## Evaluation of proposed move for Water Right No. 11317

Proposed: Move water right no. 11317 to a new well location, a distance of 2,640 ft to the southeast.

WELL TEST ANALYSIS

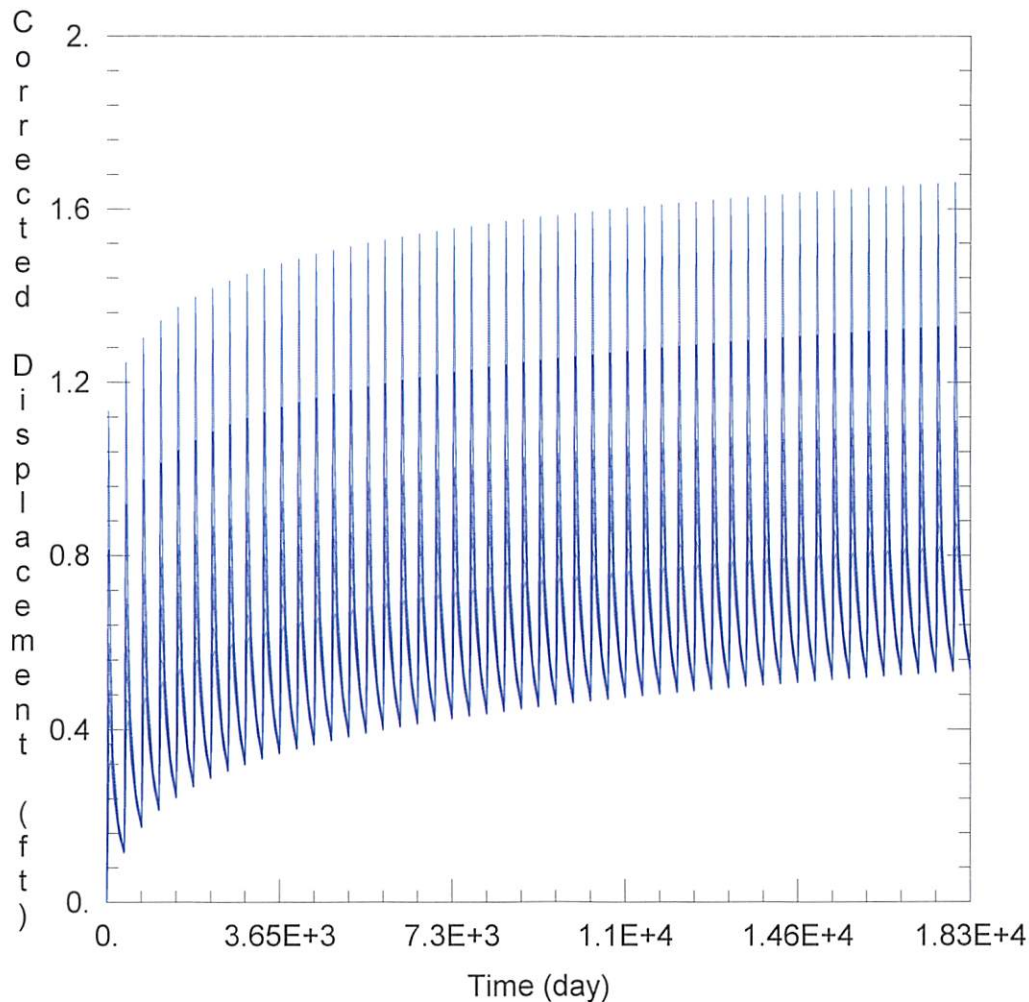
21236: Drawdown from current location = 0.09 ft  
Drawdown from proposed location = 0.82 ft  
Net drawdown = **0.7 ft**

26296: Drawdown from current location = 0.12 ft  
Drawdown from proposed location = 1.00 ft  
Net drawdown = **0.9 ft**

23753: Drawdown from current location = 0.05 ft  
Drawdown from proposed location = 1.11 ft  
Net drawdown = **1.1 ft**

2417: Drawdown from current location = 0.05 ft  
Drawdown from proposed location = 1.66 ft  
Net drawdown = **1.6 ft**

12224: Drawdown from current location = 0.08 ft  
Drawdown from proposed location = 0.88 ft  
Net drawdown = **0.8 ft**

28868: Drawdown from current location = 0.04 ft  
Drawdown from proposed location = 1.11 ft  
Net drawdown = **1.1 ft**

Domestic 3-23-35: Drawdown from current location = 0.23 ft  
Drawdown from proposed location = 1.33 ft  
Net drawdown = **1.1 ft**

Domestic 12-23-35: Drawdown from current location = 0.04 ft  
Drawdown from proposed location = 0.94 ft  
Net drawdown = **0.9 ft**

Net drawdown does not exceed the drawdown allowance of 3.0 ft for any well within 1 mile of the proposed location. Therefore, critical well analysis is not necessary.

The proposed move is likely to create minimal effects on neighboring wells and appears unlikely to cause impairment. Any concerned neighbors should contact GMD3 at (620) 275-7147 or the Division of Water Resources at (620) 276-2901.
